TY MAWR FARM LANDFILL

PPC LANDFILL PERMIT APPLICATION

SCHEDULE 4 RESPONSE

**THE POLLUTION PREVENTION AND CONTROL (ENGLAND AND WALES) 2000
REGULATIONS (SI2000 NO 1973), AS AMENDED;
THE LANDFILL (ENGLAND AND WALES) REGULATIONS 2000 (SI 2000 NO 1559)
TY MAWR FARM LANDFILL BP3330LS**

2058.SCH.01

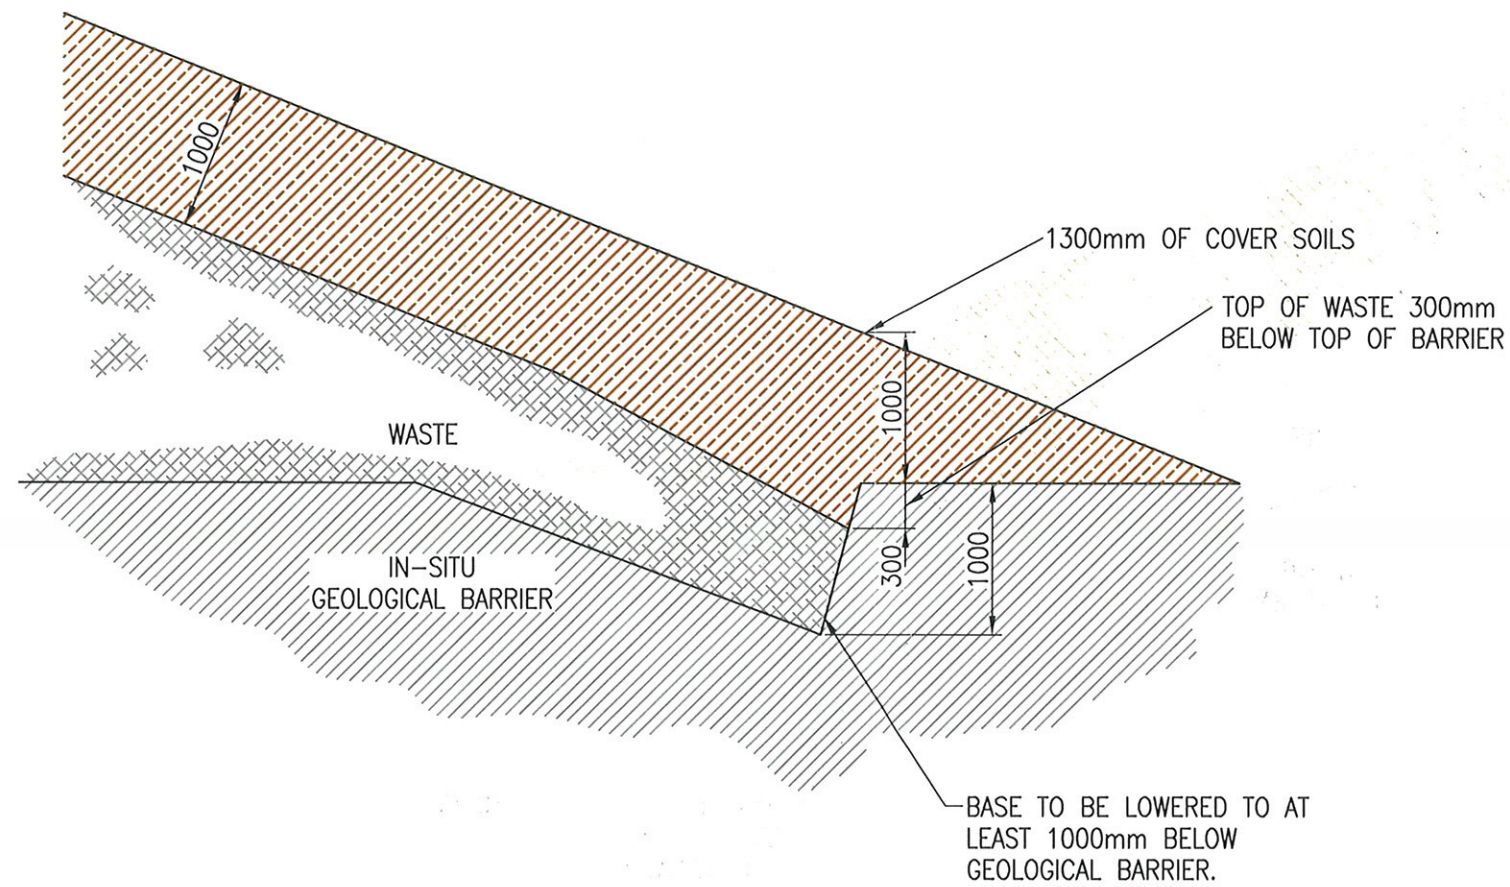
As requested, further source term characterisation of the historic waste mass was undertaken. The site owners were consulted to ensure that the trial pits were located so wastes of different ages were encountered. The locations of the trial pits are indicated on Drawing Number 2252.SCH.01, in Appendix 1.

Client: Wyn Griffiths	Northing:	Sheet: 1 of 1	Borehole ID: GW1
Site: Ty Mawr	Easting:	Job Number: A2058	
Site Engineer: D. Kountcheva	Elevation: 122 mAOD	Drill Date: 20/03/2006	
Contractor: North West Drilling

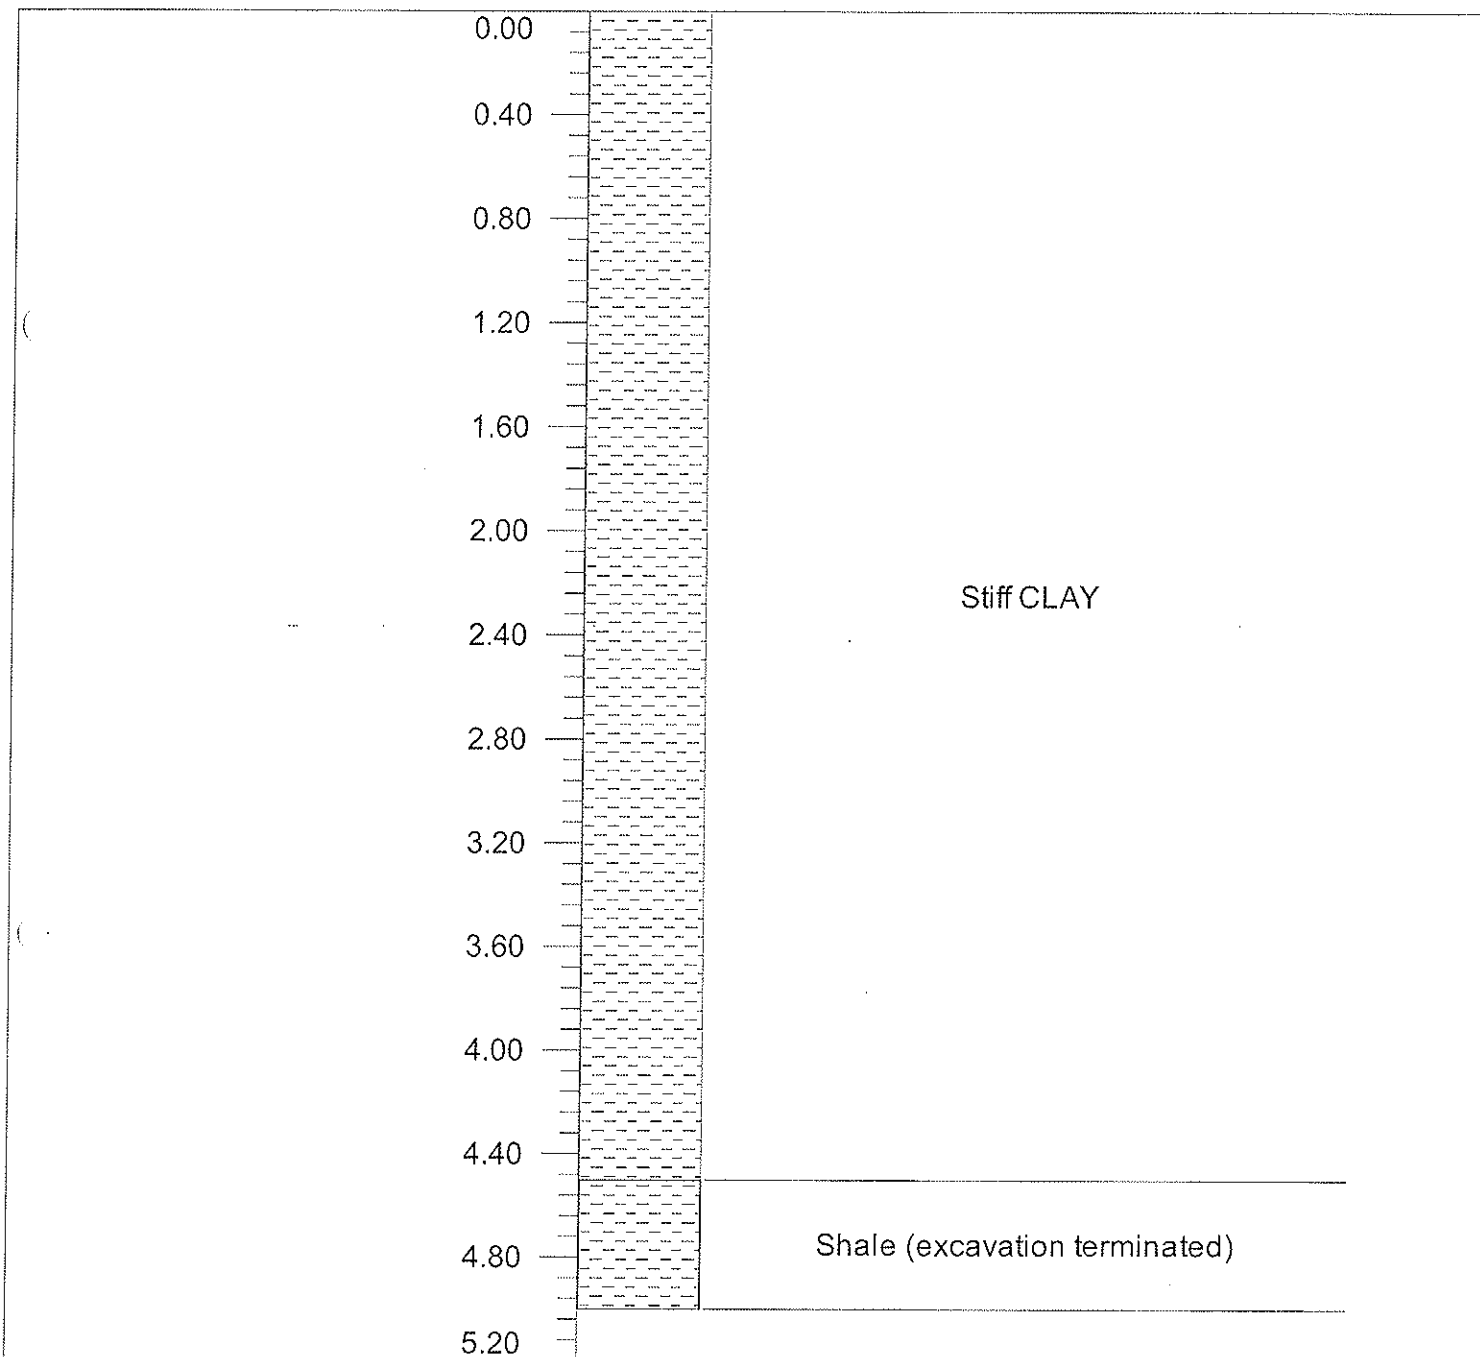
4. *Borehole log for GW1*

Borehole GW1 was the original water well, which was drilled at the site. As such, only limited information about the layers encountered is available from the site owners. This has been used to construct a borehole log, which is contained within Appendix 3.

Output from SLOPE/W

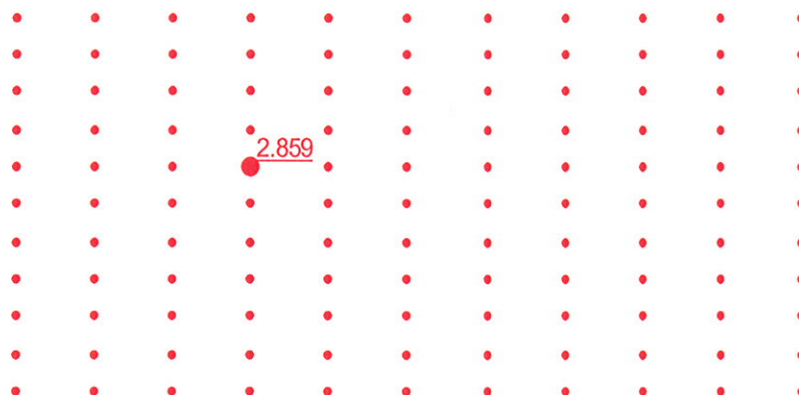
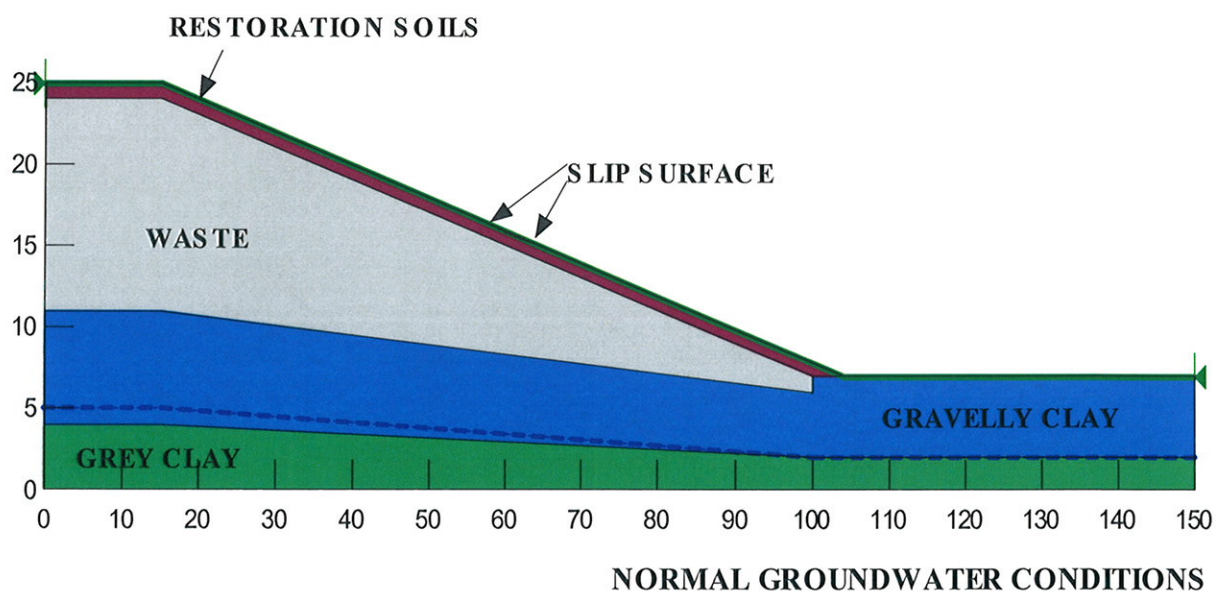
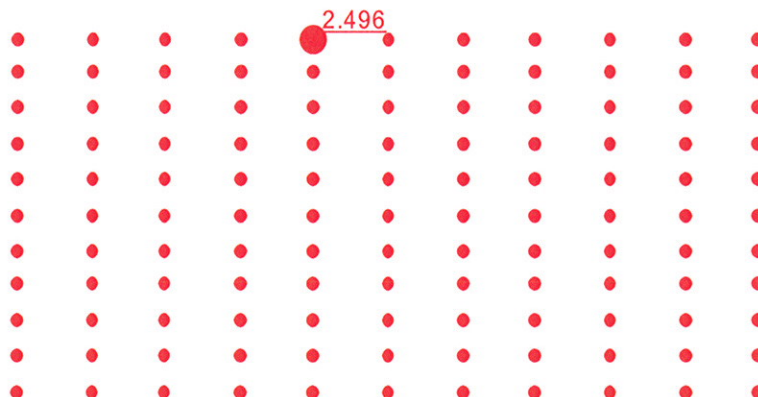
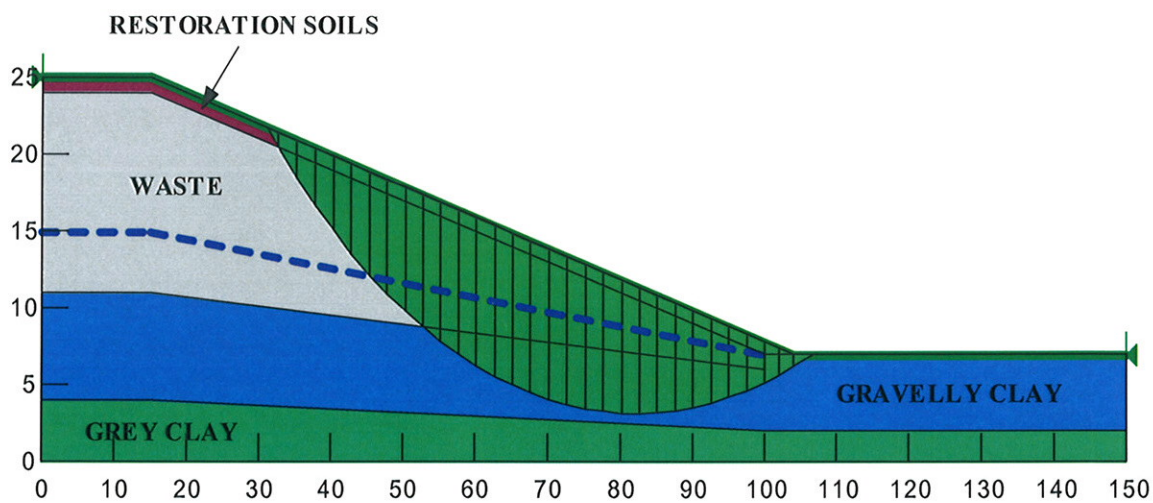
10. *Stability Risk Assessment*

- 1.3 This risk assessment has been revised to consider the potential instability of the waste and restoration soils which could be caused by pooling of water in the trough formed at the perimeter of the fill, the concern being that the trough, combined with the probable high run-off and low infiltration of surface water gives potential for saturation of the toe of the landfill. This could lead to a spring being formed at the interface with the restoration soils. The stability of the restoration profile has been considered under normal and saturated conditions.

- 3.5 Stability calculations of the completed slope have been carried out using SLOPE/W for the existing design as shown on drawing 2058.SRA.02 in both normal and saturated groundwater conditions. The calculated factors of safety, Fs, from the analyses are summarised in Table 2 and the SLOPE/W output files are enclosed in Appendix 1.

Situation	Factor of Safety (Fs)
Normal Conditions	2.859
Saturated Conditions	2.496

- 3.6 In both cases the calculated Fs values are considered acceptable. The critical slip surface under normal conditions is confined to the restoration soil layer above the waste mass with the slip surface being approximately 6m in length approximately half way down the slope, whereas the critical slip surface under saturated conditions extends through the waste mass and into the gravely clay below, the slip surface extends over approximately two thirds of the length of the slope with the toe of the slip surface daylighting past the toe of the restoration soils.
